Engineering Referral Response

Application Number:	DA2025/0412
Proposed Development:	Demolition works and construction of a dwelling house including a swimming pool
Date:	29/05/2025
То:	Dean Pattalis
Land to be developed (Address):	Lot 82 DP 866452 , 10 Manor Road INGLESIDE NSW 2101

Indicative location of Council's Stormwater Assets as below.

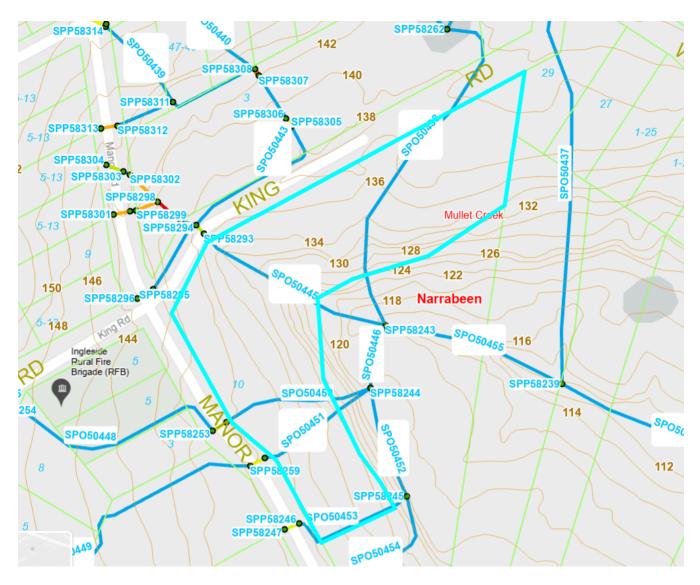
- As the proposed development sits predominantly outside of the flood affected zones, an OSD system shall be provided in accordance with Council's 'Water Management for Development Policy' when the proposed increase in impervious area is more than 50sqm.
- Council's stormwater system adjacent to the proposed development (including the driveway) shall be located on the survey plan by a service locater/registered surveyor and shown on the architectural plans to demonstrate that the proposed development will not adversely affect

Council's stormwater system. A map showing the indicative location of Council's stormwater system is attached at the end of this referral letter.
